ADDENDUM NO. 3 TO PROJECT NO. 44808

CONSTRUCTION WORK, HVAC WORK, PLUMBING WORK, AND ELECTRICAL WORK
RENOVATE BUILDING NO. 5
STATE OFFICE BUILDING CAMPUS
1220 WASHINGTON AVENUE
ALBANY, NY

December 5, 2013

1ST FLOOR FIRE PROOFING PLAN

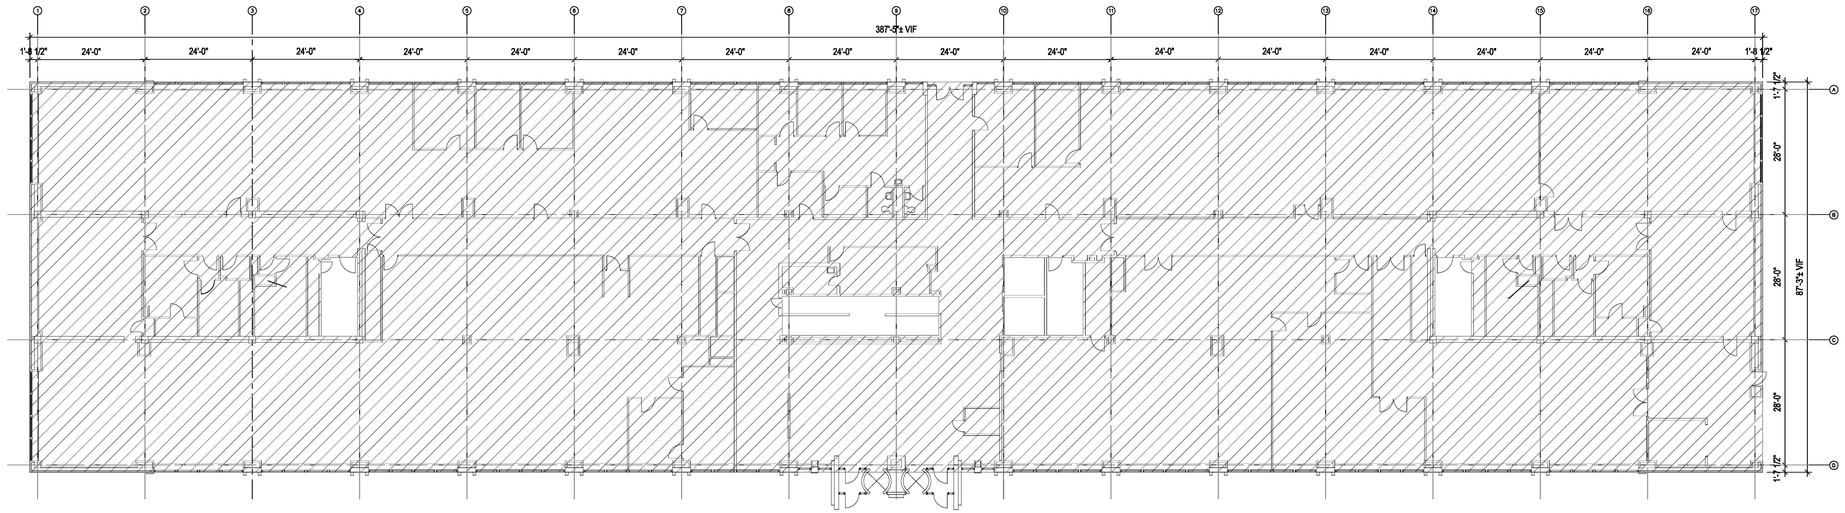
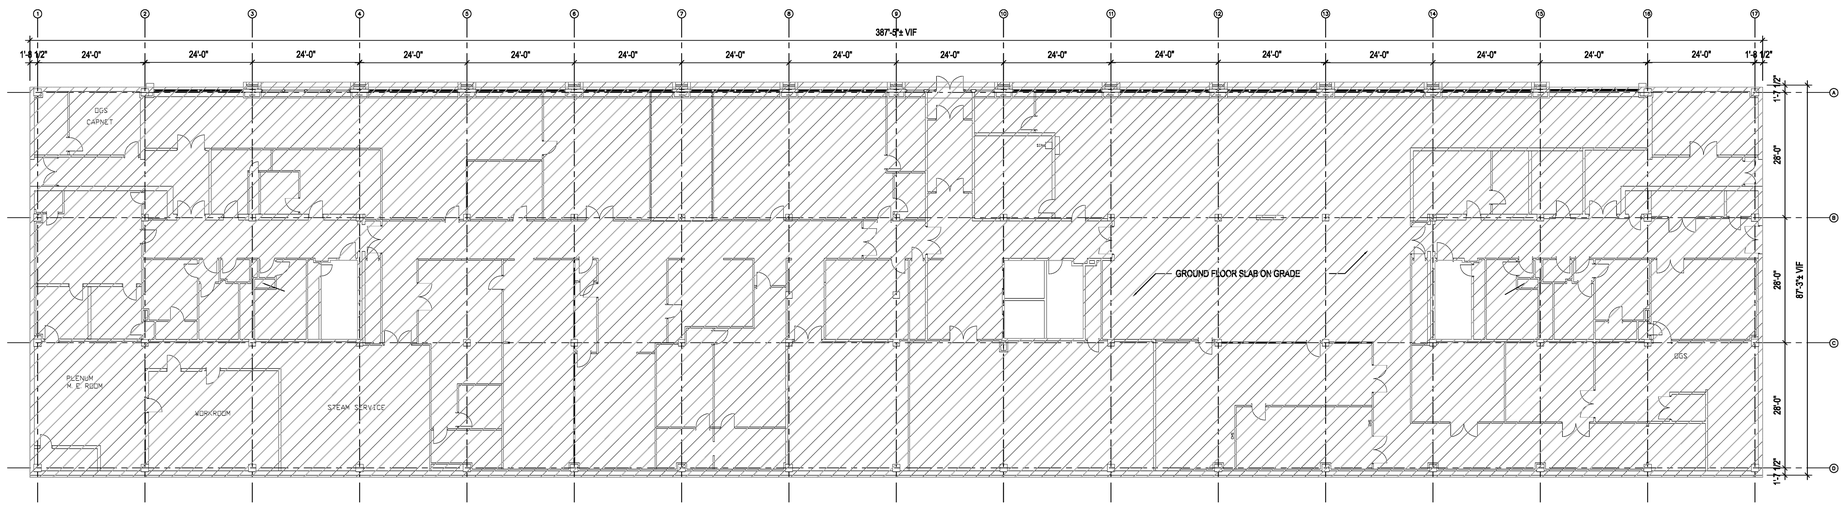
"5. Provide spray on fireproofing at the ground floor ceiling (1st Floor Framing Plan) for all beams, columns and floor deck. See reference Drawing F-100 for UL Listing and thickness requirements."

DRAWING NUMBER:
E-014

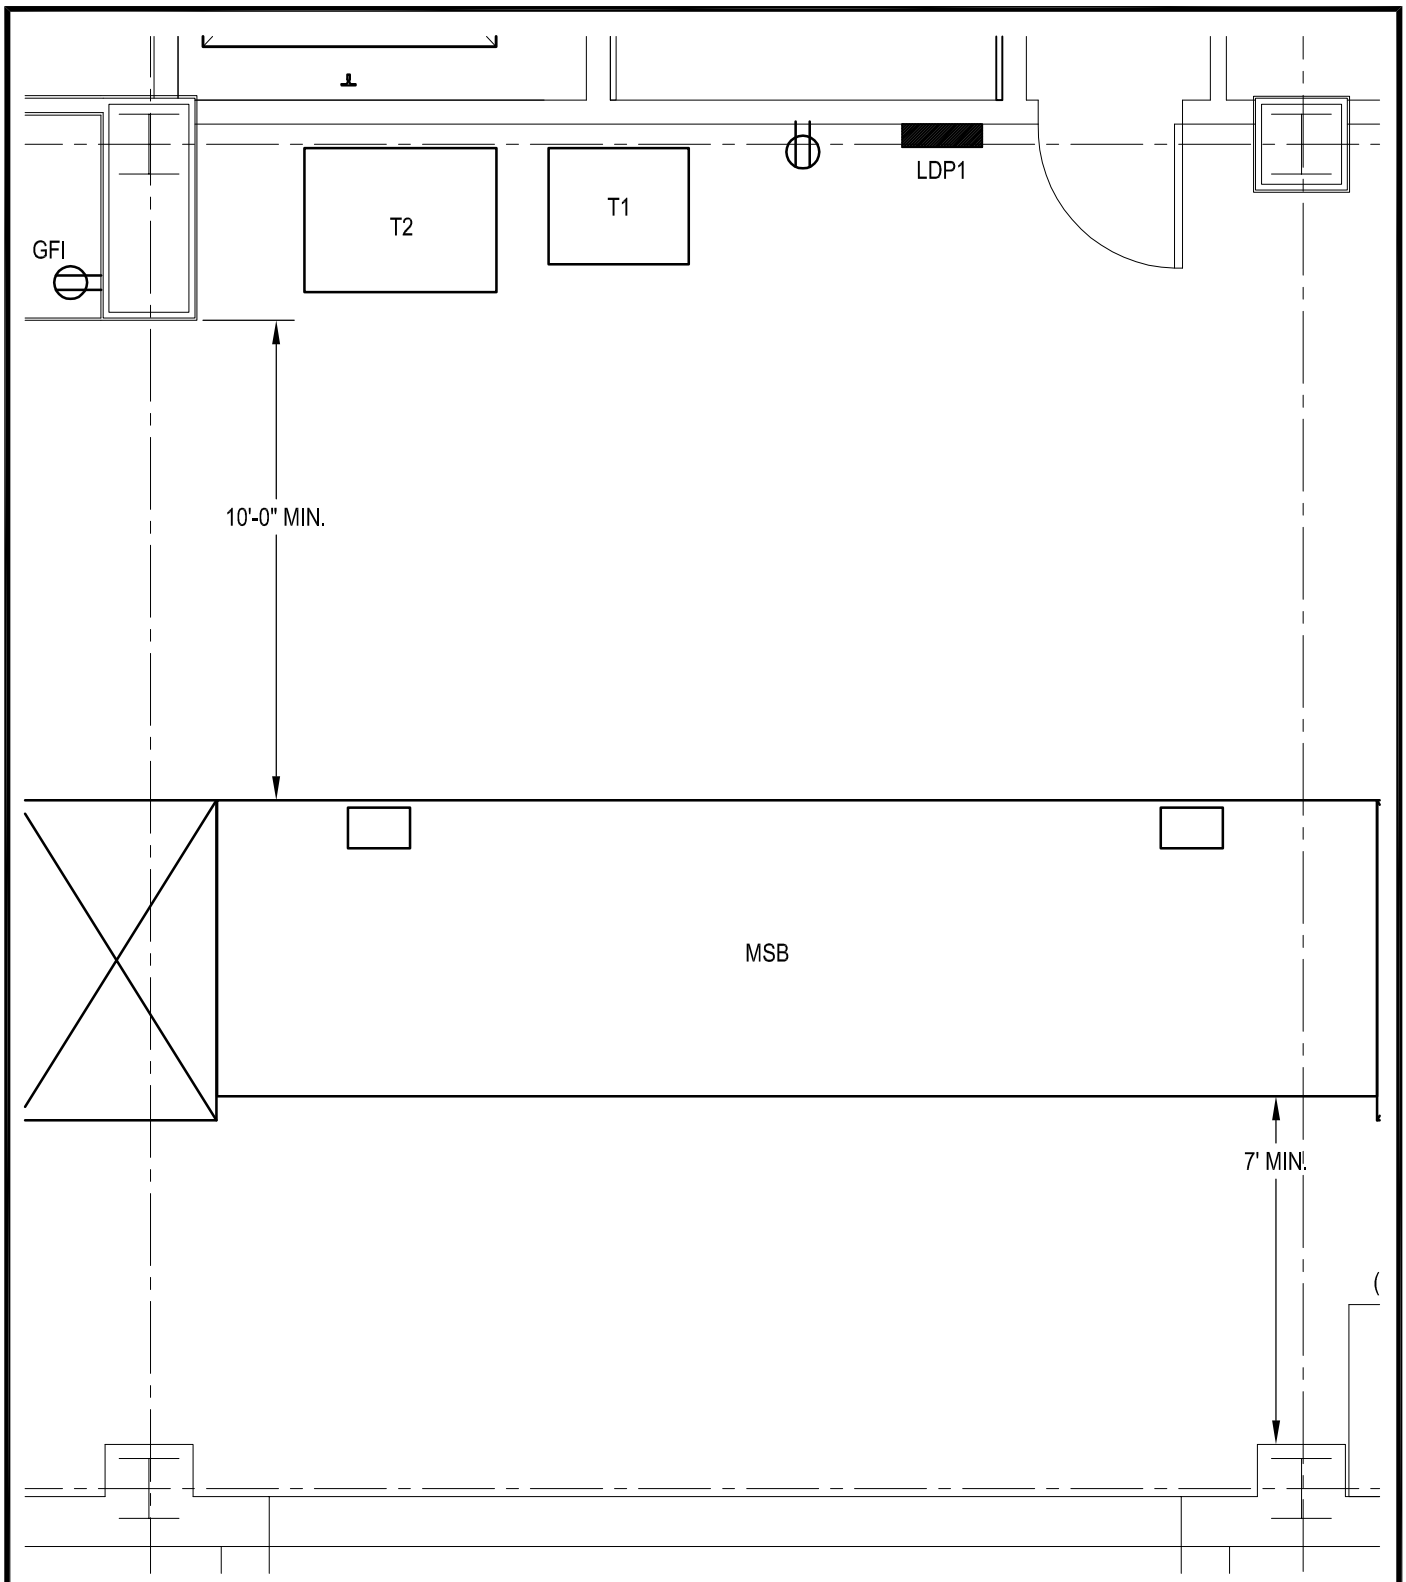
109. Drawing No. E-003, DETAIL 3/E-003: Revise dimensions in main electric room as shown on Addendum Drawing No. E-015, dated 12/2/13.
